Burlington Design Advisory Board

To: The Design Advisory Board
From: Ryan Morrison, Associate Planner
RE: ZP21-0667CA; 90 Ethan Allen Parkway
Date: March 9, 2021

Request: Construct four detached hotel/motel-room-rental structures, relocate existing garage, construct fencing, and expand the existing driveway and resurface with gravel.

1. 21-0667CA; 90 Ethan Allen Parkway (NAC, Ward 7N) Rolf Danielson

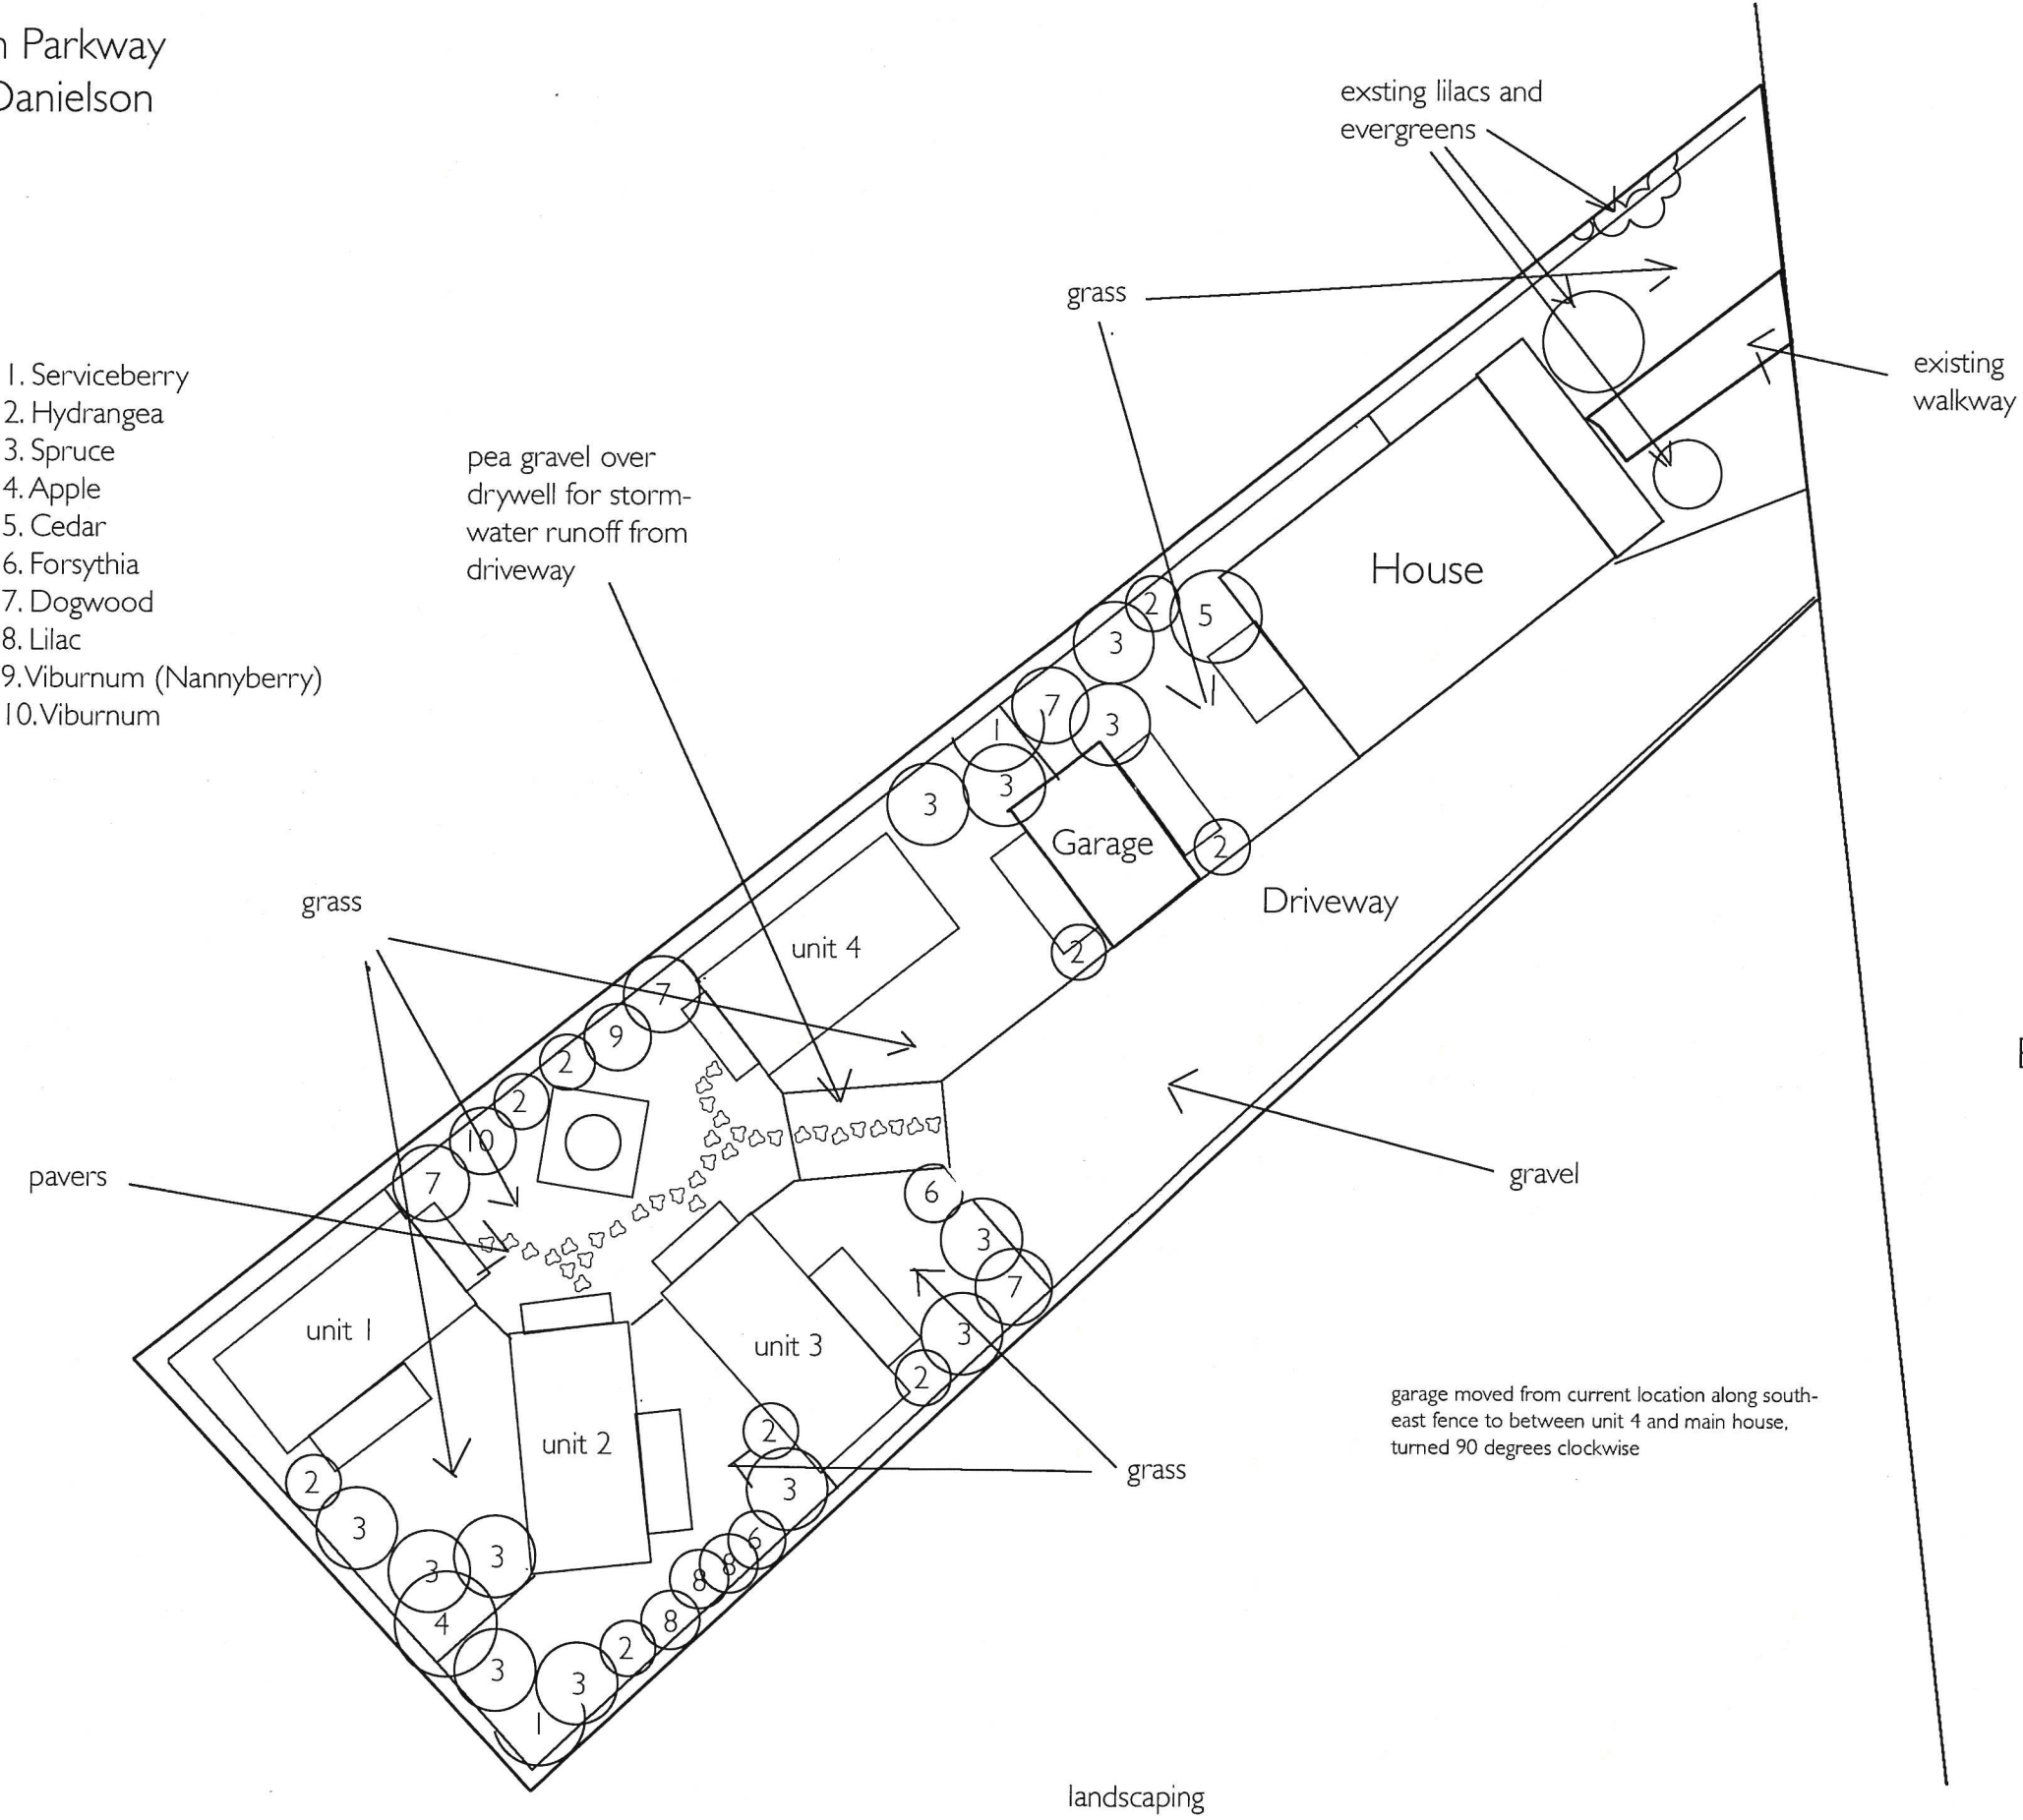
1. There needs to be an unobstructed walkway between the Ethan Allen Pkwy sidewalk and the 4 new guest rooms/units in the rear of the property. As proposed, guests will have to walk along the driveway to get to their lodging. One other possibility is providing pedestrian access through the structure at the front of the property that was recently approved as a hotel/motel use, and then providing a walkway from the backdoor to the new structures.
2. While there is no minimum parking requirement, no more than 6 parking spaces can be permitted on the property. The plans should be updated to show where parking will occur within the driveway, while also taking into account the one-car garage that may or may not be used for parking.
3. Garbage/recycling storage – where will this occur?
4. All utility lines to the four new structures will have to be underground.

1. Add landscape lighting to illuminate the walkway from the street to the guest units.
2. Reduce the amount of interior fencing to allow for better sightlines within the property and minimize unsafe spaces.
3. An effective barrier be added to prevent cars from parking on the front lawn, such as curbing, low landscaping or fencing.
